Applicant: LIFETOUCH National School Studios, Inc. (owner)
Drive Shack Holdings, LLC (applicant)

Location: 7800 Picture Drive

Request: 1) Rezoning from CO-1 Commercial Office 1.0 to CO-1(PD) Commercial Office 1.0 (Planned Development);
2) Preliminary and final development plans for a major commercial golf facility; and
3) Conditional use permit for a major commercial golf facility.

PROPOSAL

Graphic 1: Proposed Rezoning to apply PD Overlay at 7800 Picture Dr.

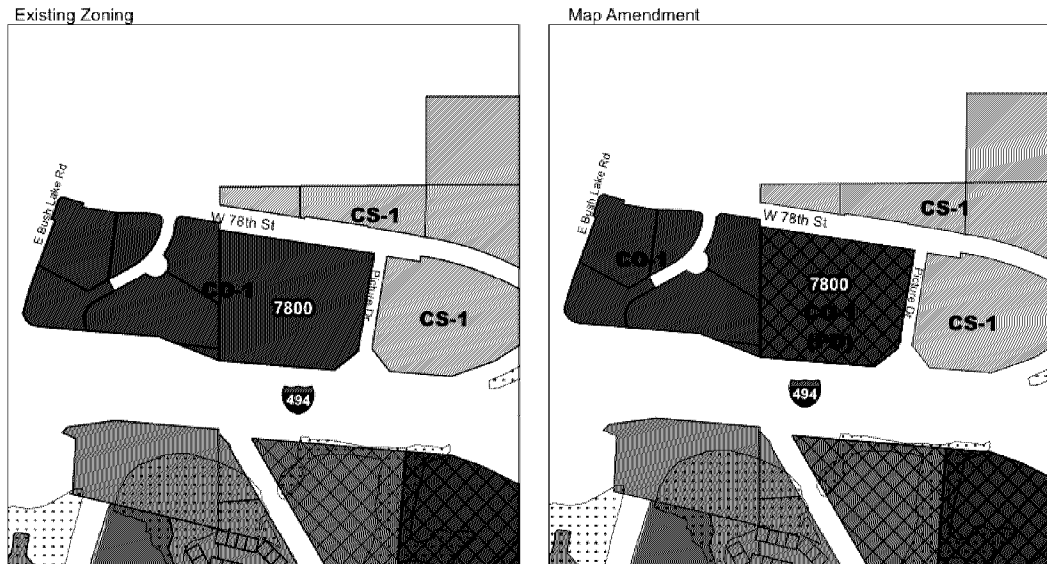
Staff believes the proposed rezoning to apply the planned development overlay, as depicted in Graphic 1 below, is consistent with the Comprehensive Plan and provides a public benefit through the introduction of standards flexibility for the unique needs of recreation/entertainment uses. In the following performance standards section, staff identifies the requested flexibility for the project. Staff recognizes the public benefit for most, but not all of the requested Planned Development deviations as they accommodate a complete redevelopment with a unique land use.
